Re: Comments on the draft Desert Renewable Energy Conservation Plan and
EIR/EIS, Docket No. 09-RENEW EO-01

California State Parks comments on the Draft DRECP EIR/EIS

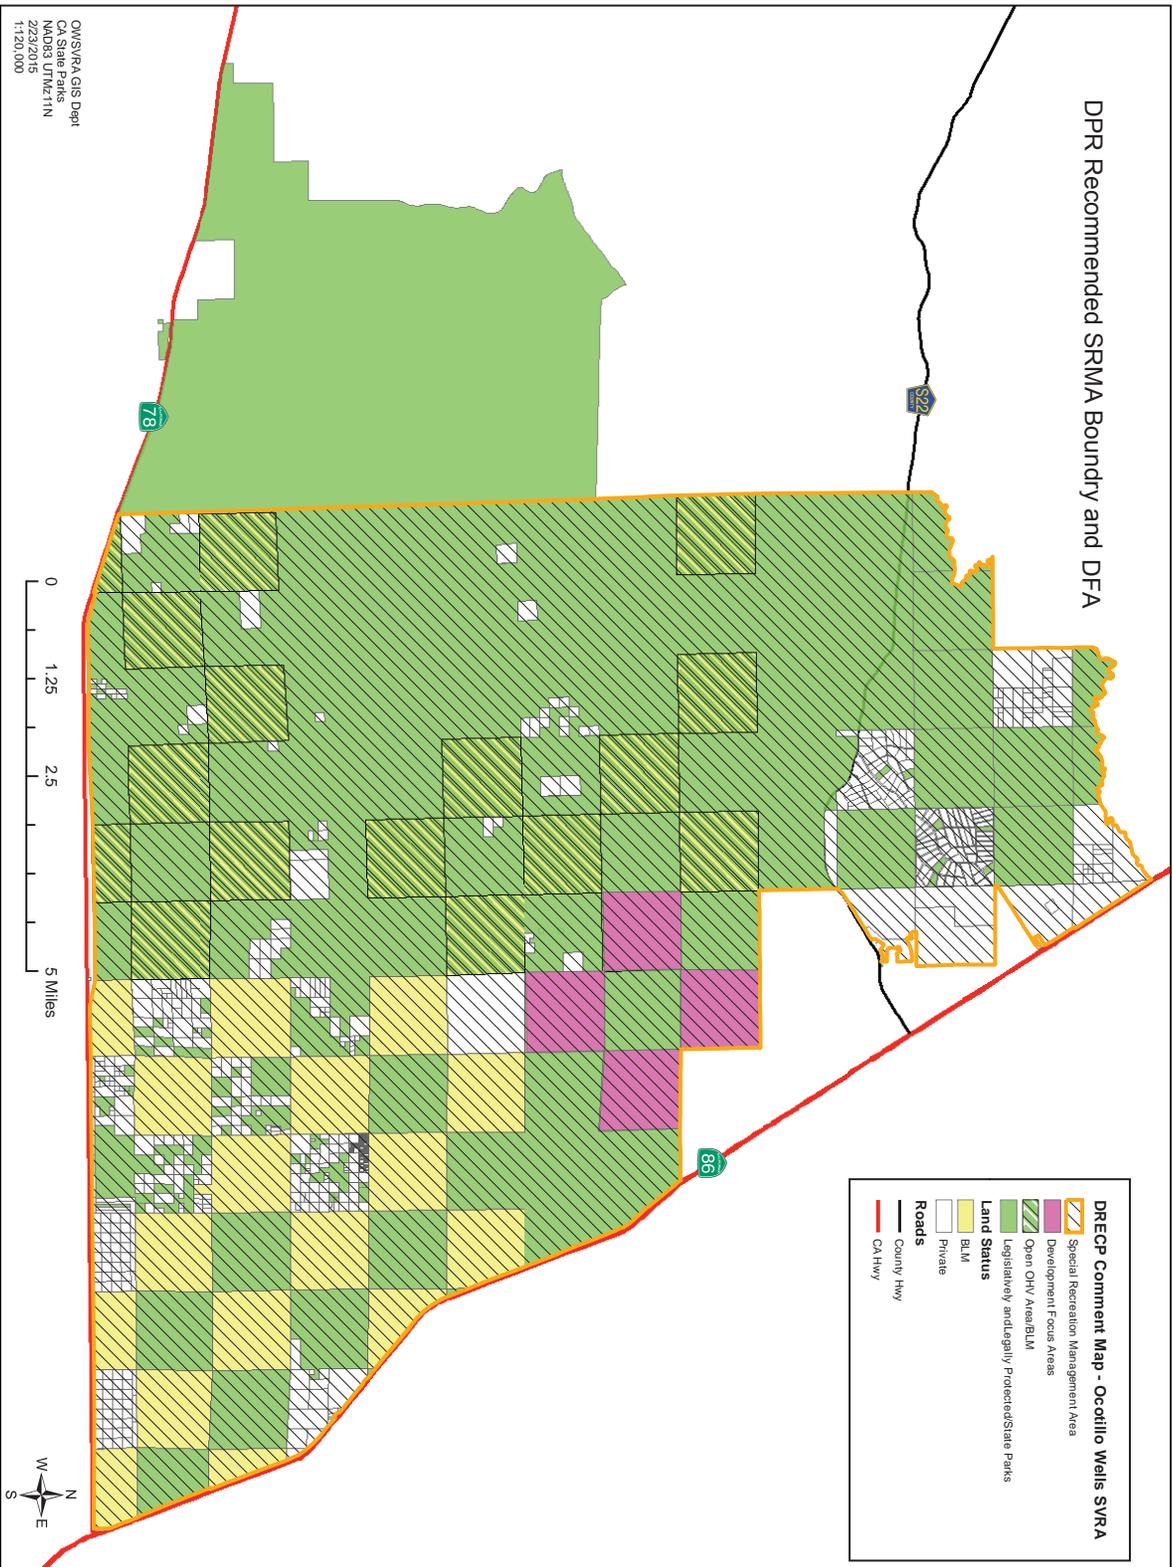
Comment [CSP1]: CSP is tasked with protecting "un recorded resources as well"

Review for FIGURE II.3-3, Preferred Alternative - Plan-wide DFAS

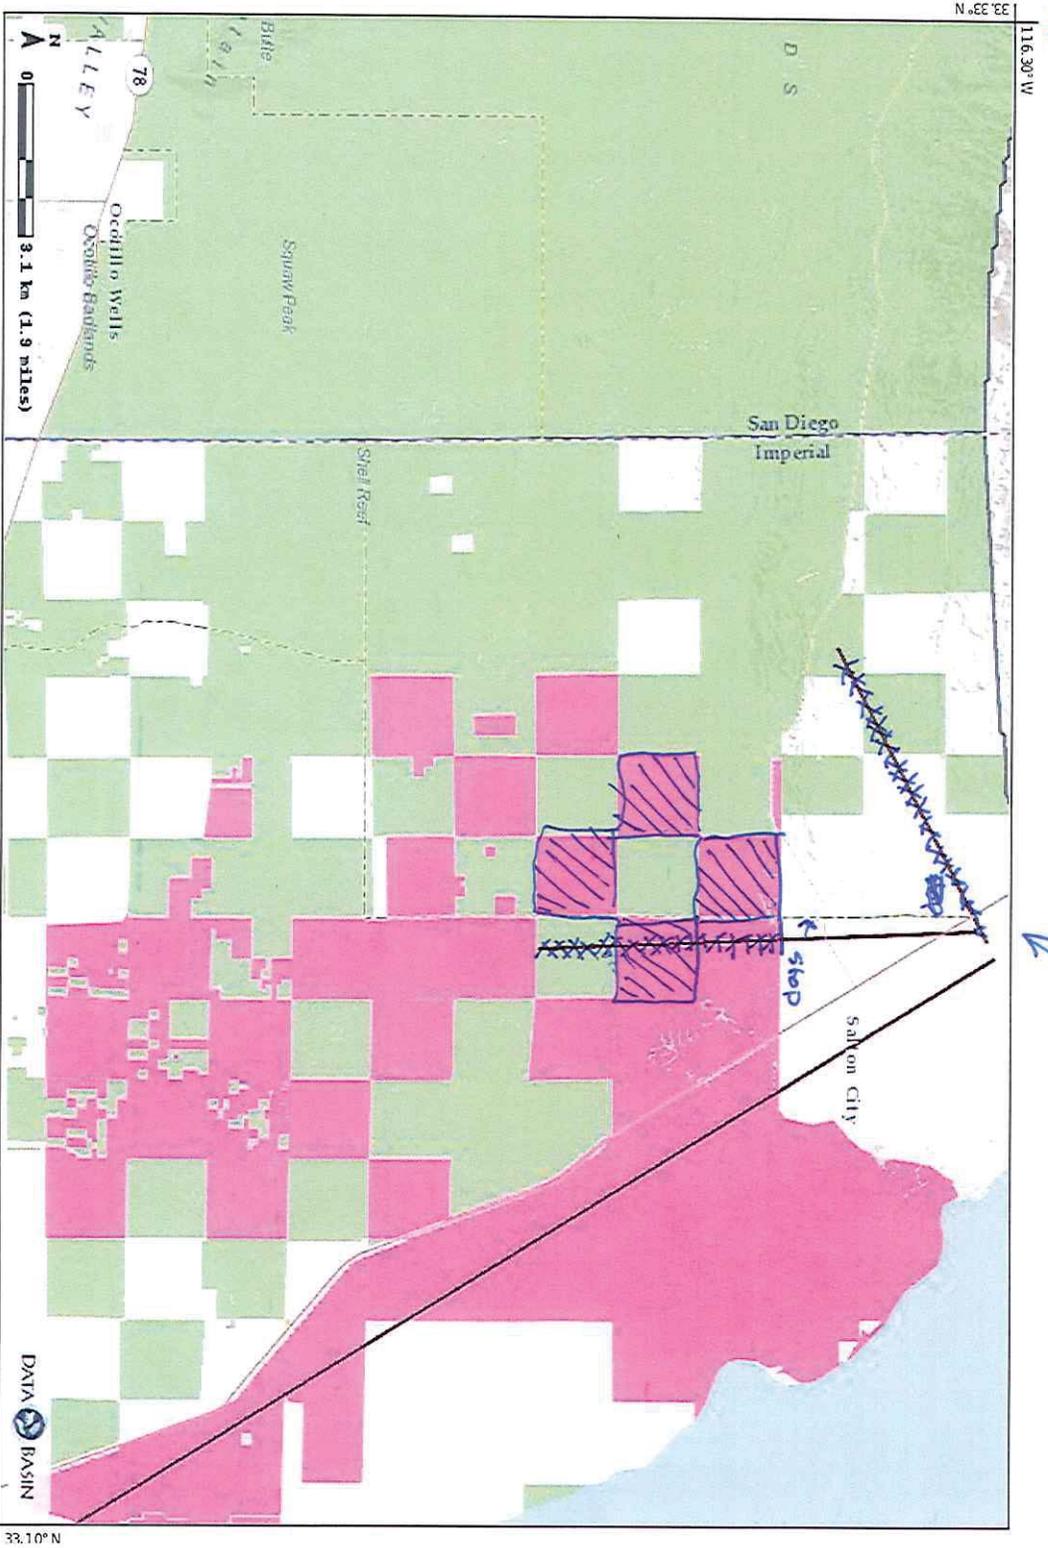
remove DFAs from Ocotillo Wells SVRA SRMA in following priority:

- 1) no surface occupancy in any alternative/stop transmission corridors at OWSVRA boundary
- 2) no DFAs on private property which are inholdings in SVRA and prioritized for purchase with OHV Trust funds
- 3) Remove DFAs from expired leases on BLM *everything but the sections as* 
- 4) Remove all DFAs

Review for FIGURE II.3-4, Interagency Preferred Alternative - BLM LUPA

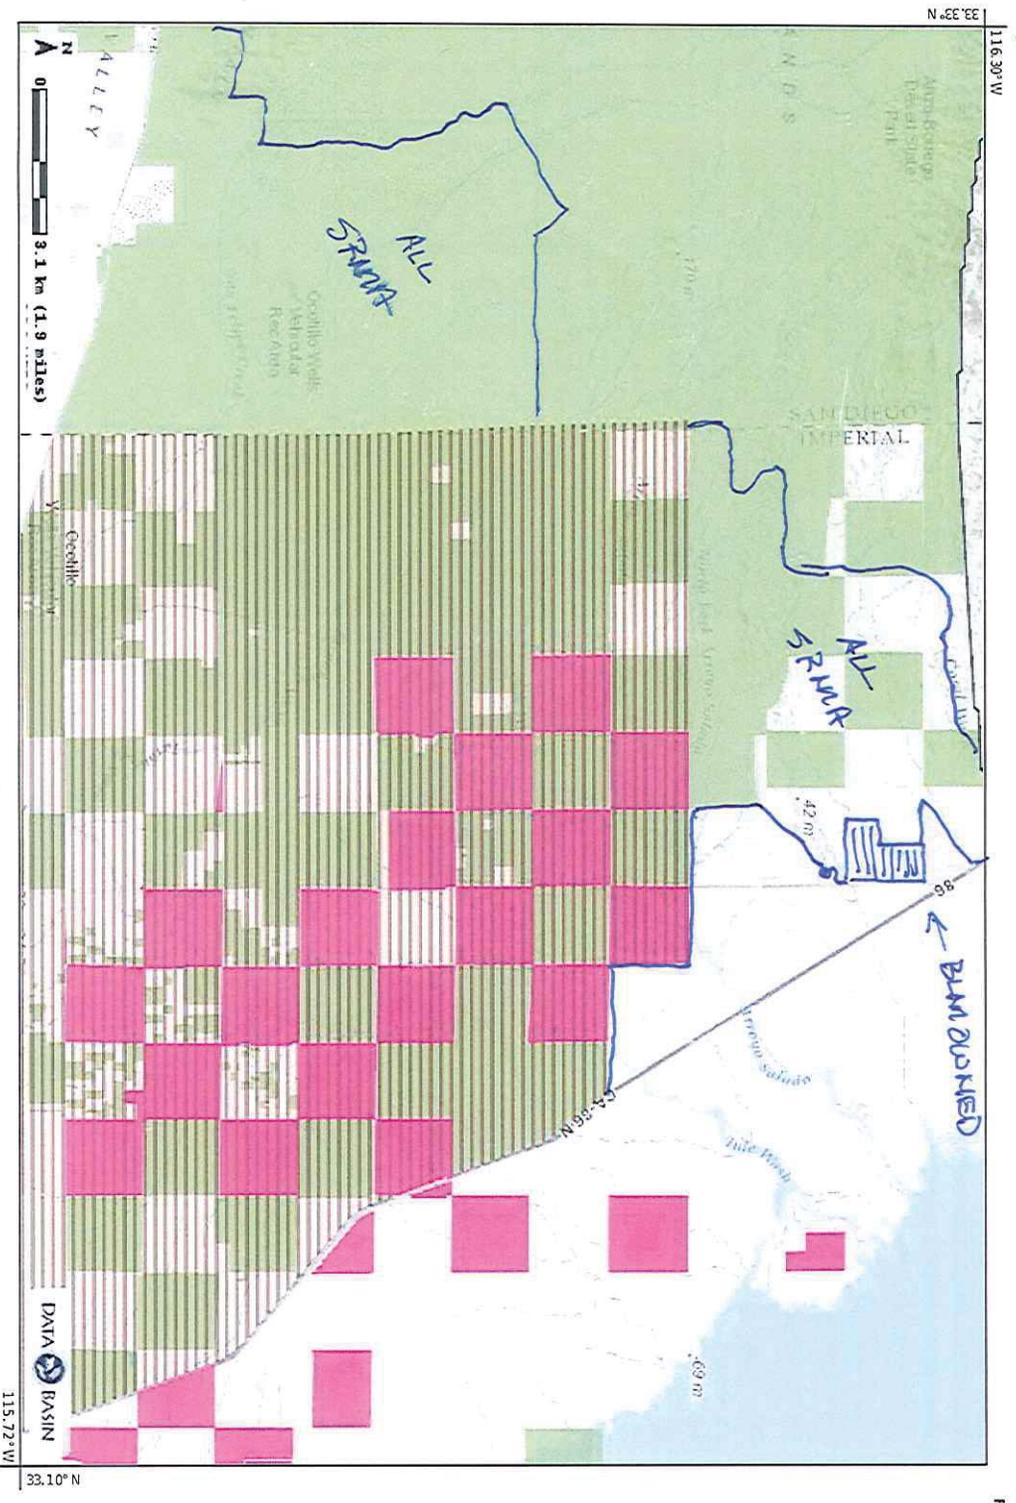
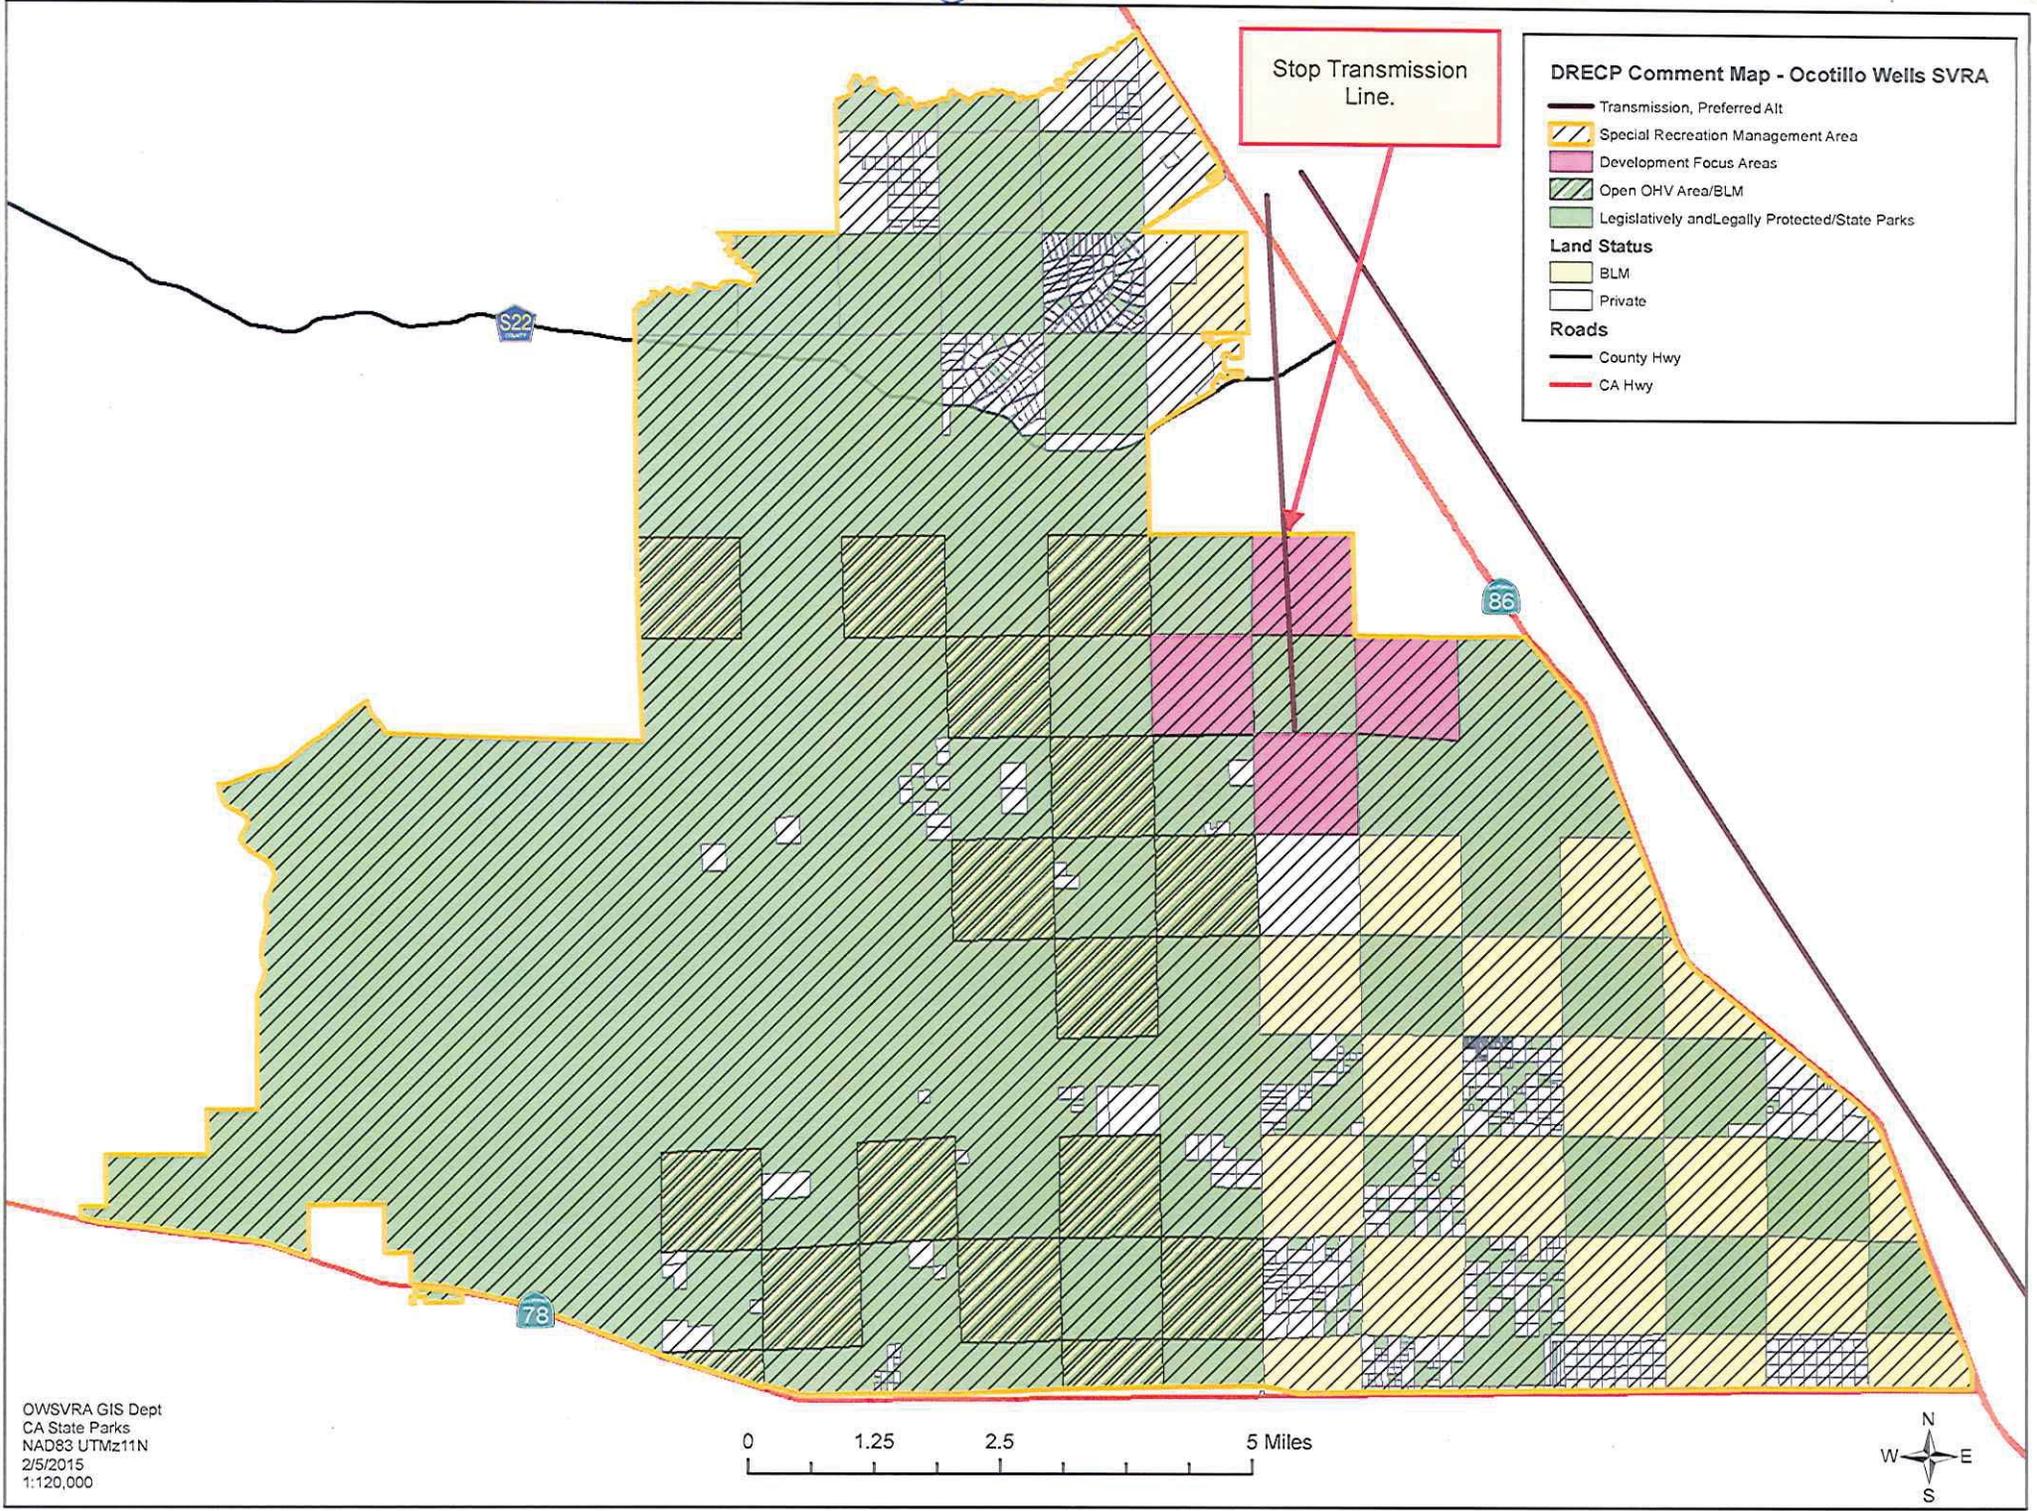
Please note our suggested replacement map. Please add BLM property north of S-22 and next to Poleline Road and all the rest of Ocotillo Wells SVRA to the SRMA.

For FIGURE 11.3-4 @ this location & for OW East SRMA - all alternatives

Review for FIGURE II.3-7, Preferred Alternative - Natural Community Conservation Plan

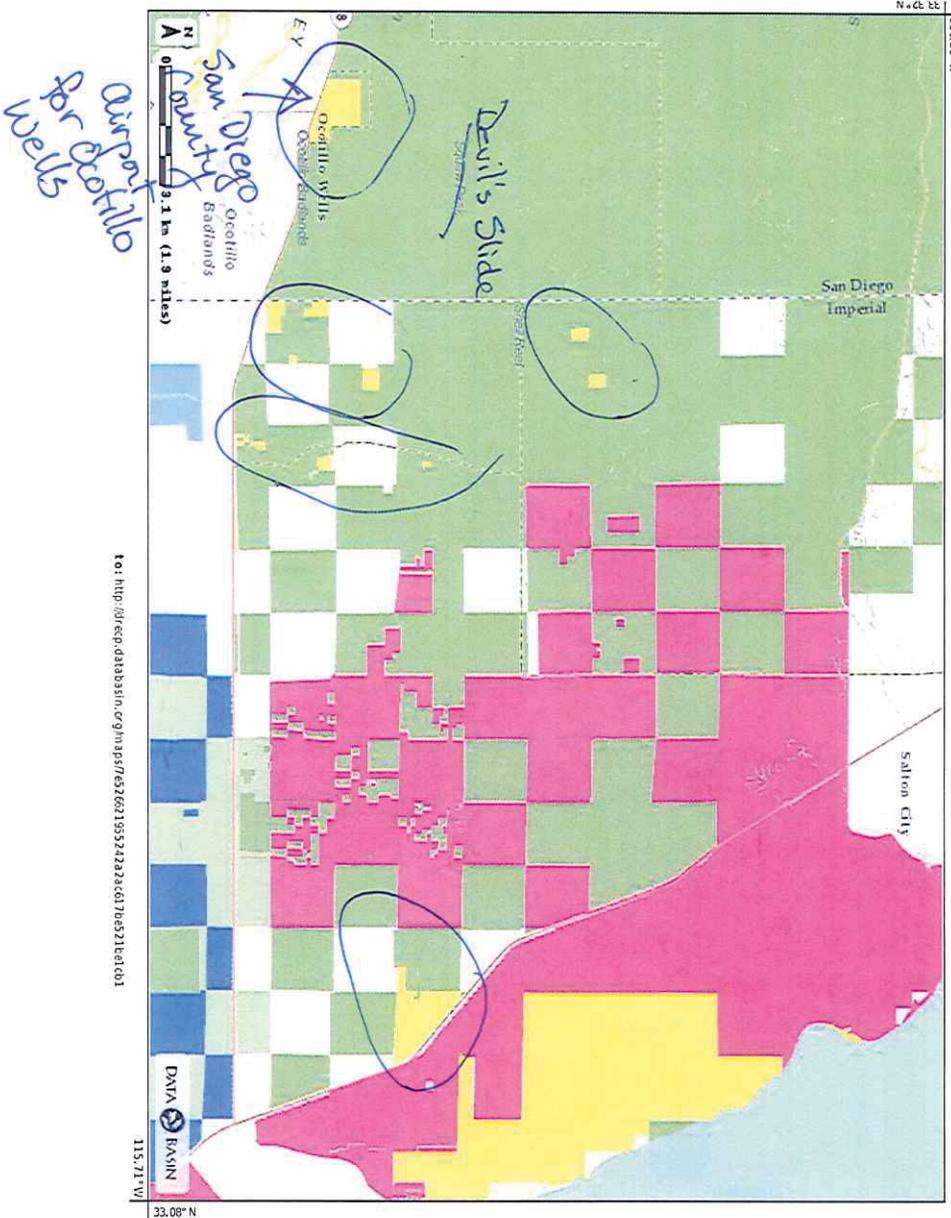
Please remove the yellow and light green biological conservation areas from within OWSVRA. These areas are inholdings that are prioritized for purchase with OHV Trust funding and they would be managed under the OHMNR resource protection guidelines. Also, please remove "Squaw Peak" from all the maps as the name has been changed to "Devil's Slide"

REVIEW FOR FIGURE II.3-8, Interagency Preferred Alternative - General Conservation Plan Non-BL

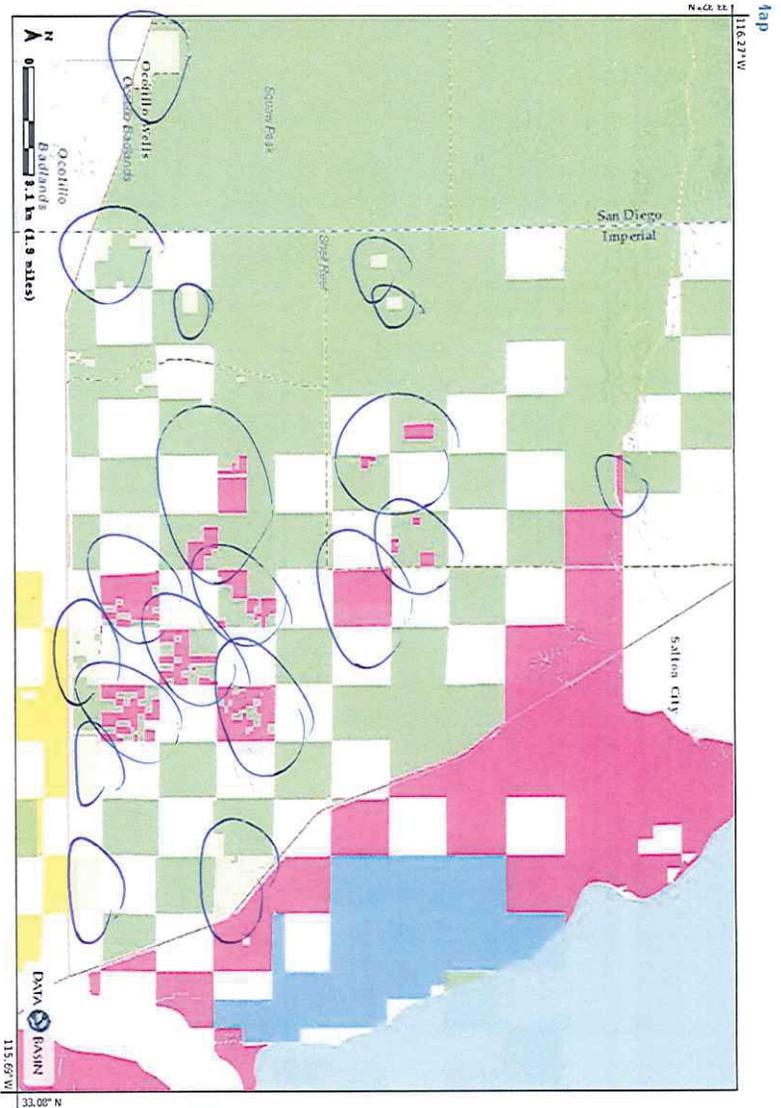
Please remove the private inholdings within OWSVRA as DFAS because most do not have existing legal access and most are zoned recreation and open space. Also remove the Conservation Planning areas - the light green within OWSVRA.
